Your ref
APP/20/01225

Our ref
PLAN-037328

Proposal: Demolition of existing ground floor rear extension and rebuild single storey rear extension.
Site: APP/20/01225: - 56 Stakes Hill Road, Waterlooville, PO7 7LB.

Southern Water MapGuide Browser

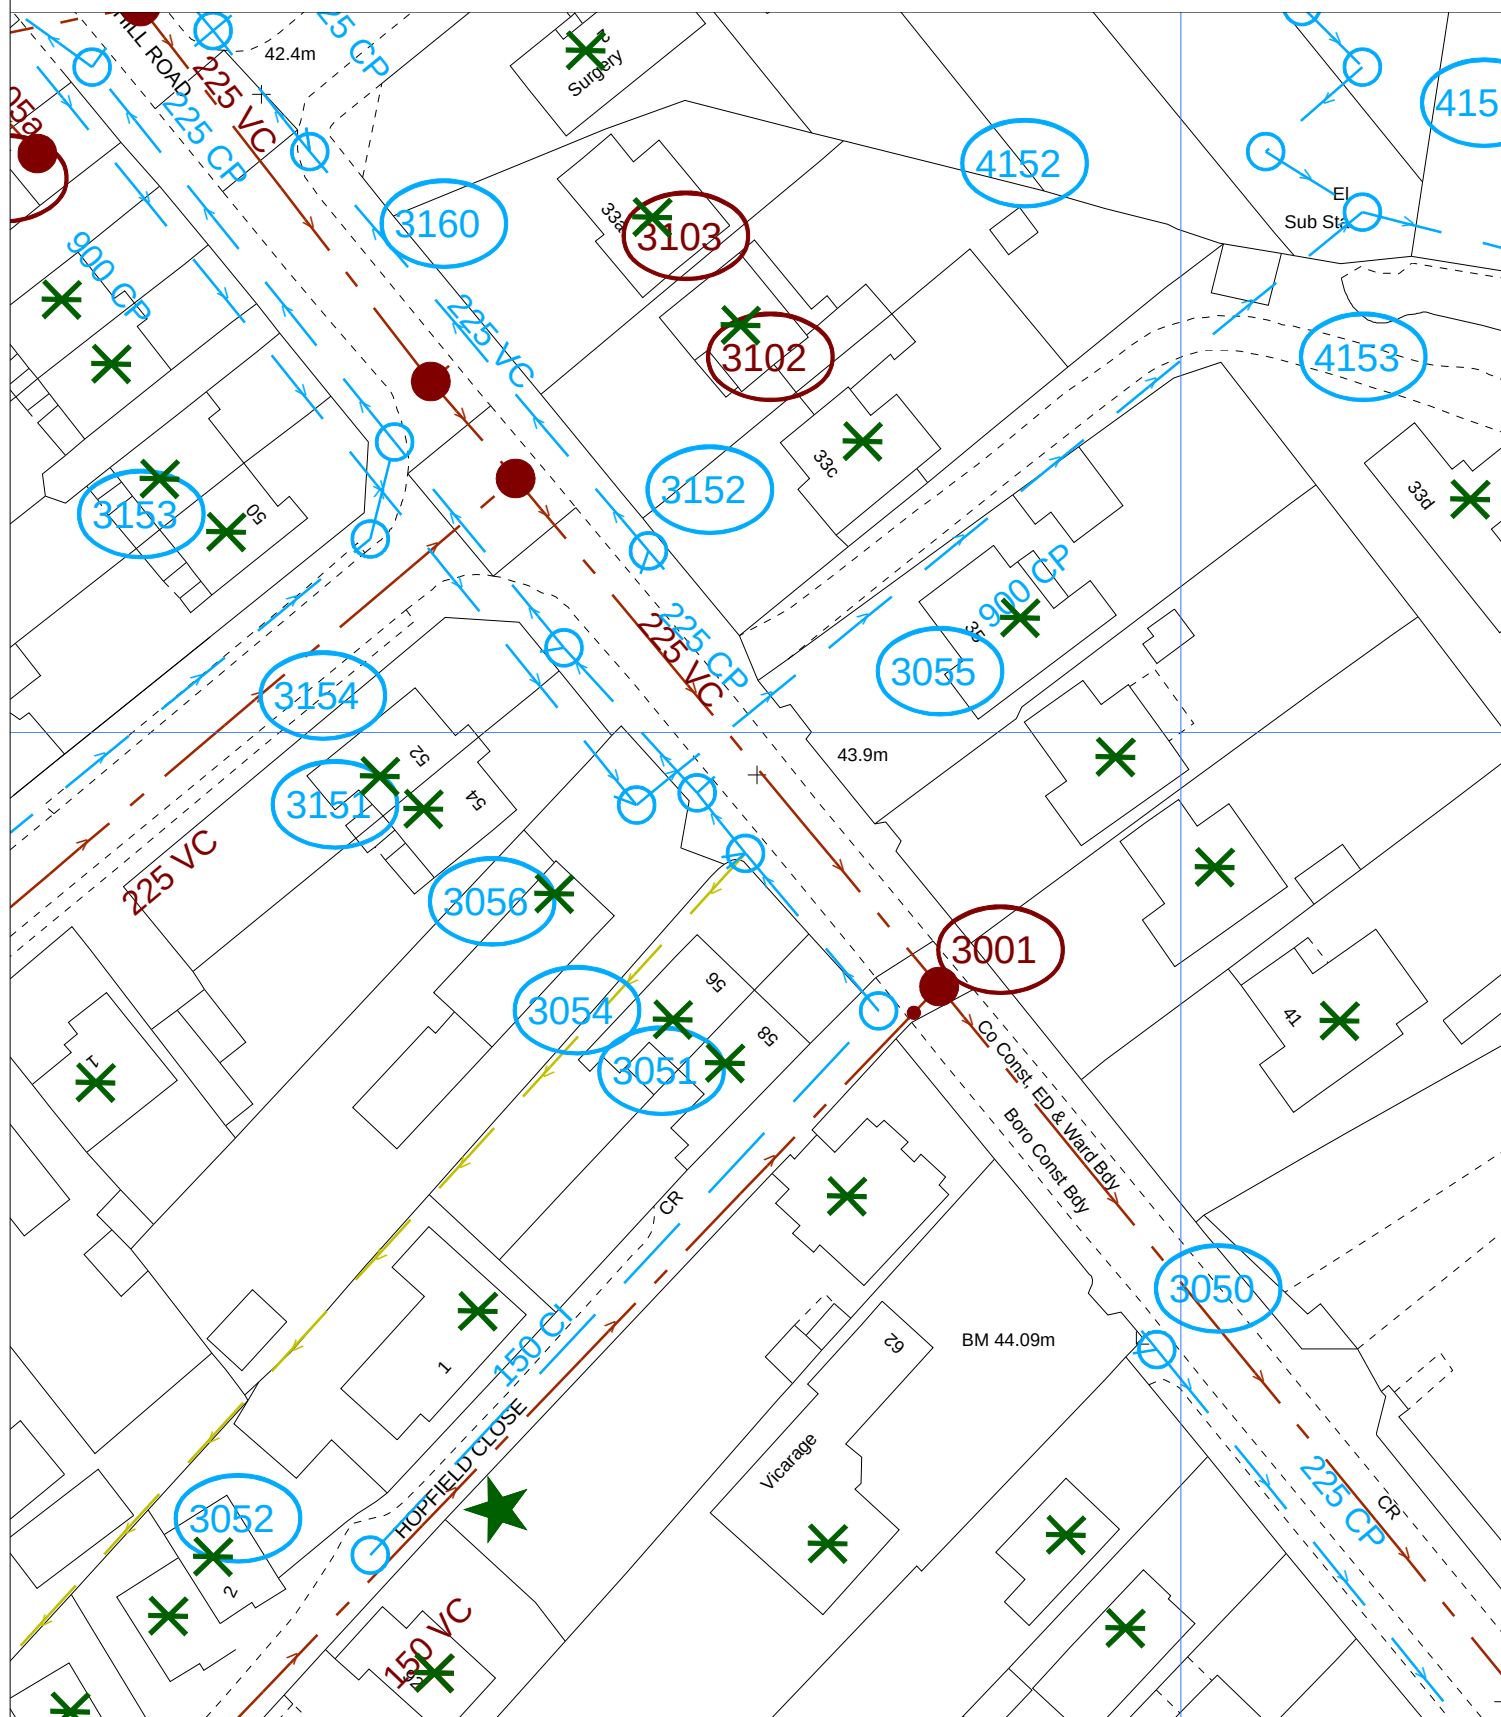
Please see the attached extract from Southern Water records showing the approximate position of our existing surface water sewer immediate vicinity of the development site. The exact position of the public assets must be determined on site by the applicant in consultation with Southern Water before the layout of the proposed development is finalised.

- The 150 mm diameter gravity surface water sewer requires a clearance of 3 metres on either side of the gravity sewer to protect it from construction works and to allow for future maintenance access.
- No development or tree planting should be carried out within 3 metres of the external edge of the public gravity sewer without consent from Southern Water.
- No soakaways, swales, ponds, watercourses or any other surface water retaining or conveying features should be located within 5 metres of a public sewer.
- All existing infrastructure should be protected during the course of construction works.

Further, it is possible that a sewer now deemed to be public could be crossing the development site. Therefore, should any sewer be found during construction works, an investigation of the sewer will be required to ascertain its ownership before any further works commence on site.
